## ADDENDUM TO SPAD XIII ASSEMBLY STEP 3, ITEMS 2 & 3: ATTACHING THE STEPS TO THE EXHAUST PIPES

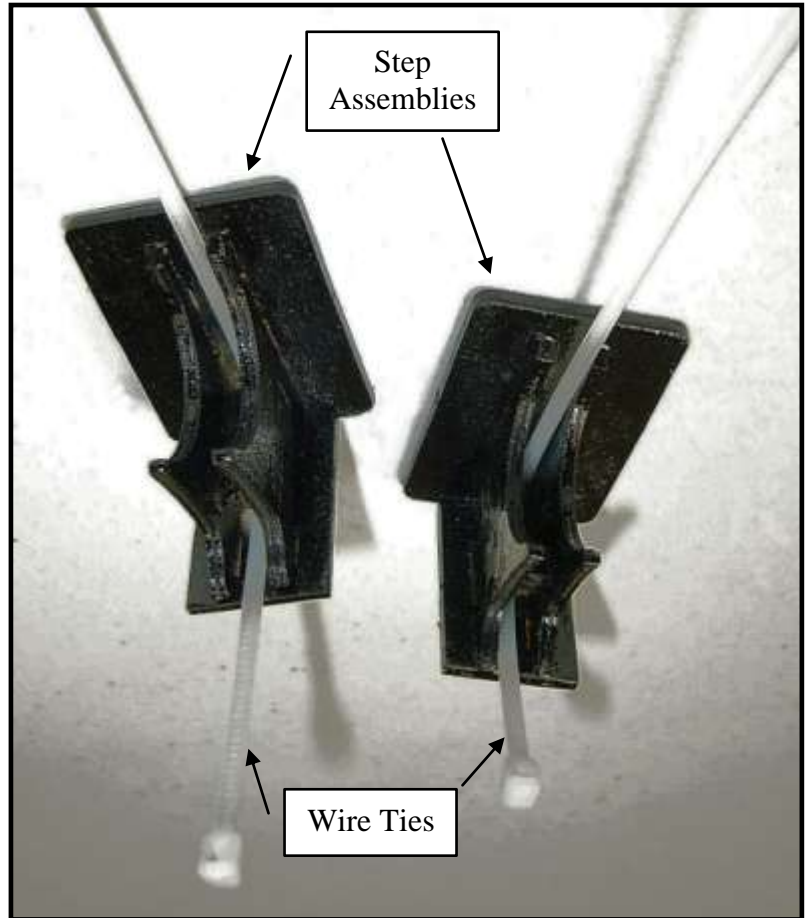
1. Make a bend in the ends of two nylon wire-ties and guide each wire tie into the opening in each step assembly as shown in the photo at the right.
2. Use long-nosed pliers to pull each wire tie fully through the opening in each step assembly.
3. Position the step assemblies against the exhaust pipe as shown in the photo below. Guide each wire tie around its exhaust pipe, into and through the wire tie's locking end, then firmly tighten each wire tie against its exhaust pipe to secure the step assemblies to the exhaust pipes. Cut and discard the wire ties' excess length.

4. To provide greater flexibility in exhaust pipe placement, the indentations in the fuselage mentioned in item 3 and shown in the photo at the bottom of page 8 have been eliminated.
